Product Change Notification / MFOL-13IGZT584

CCB 5258 Final Notice: Implement new packing materials and packing changes for selected ATSAMxxx, AT91Rxxx, AT91Sxxx device families available in 100L LQFP (14x14x1.4mm) package.

CCB# 5258
PCN #: MFOL-13IGZT584

Pre and Post Change Summary – Tape and Reel

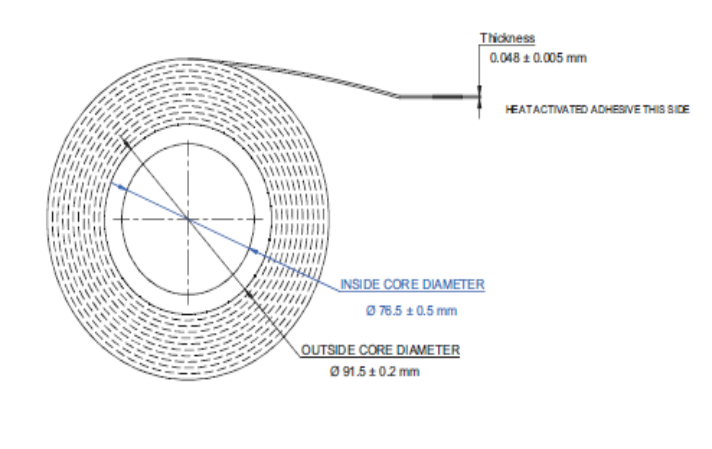
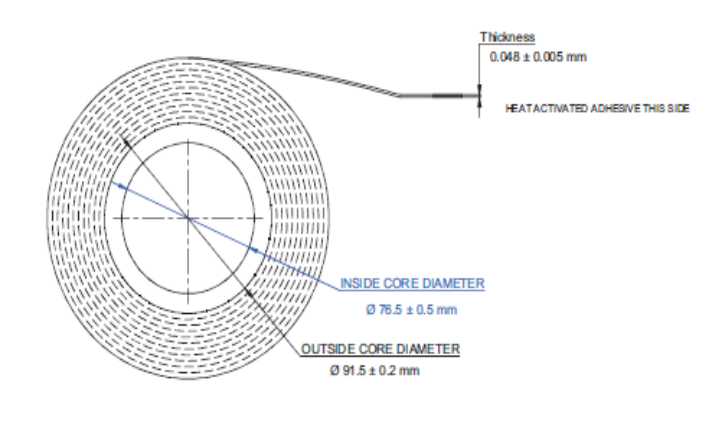
Pre Change	Post Change
Base Quantity Multiple (BQM)	Units per reel: 1000 1 reel per bag	Units per reel: 1000 1 reel per bag
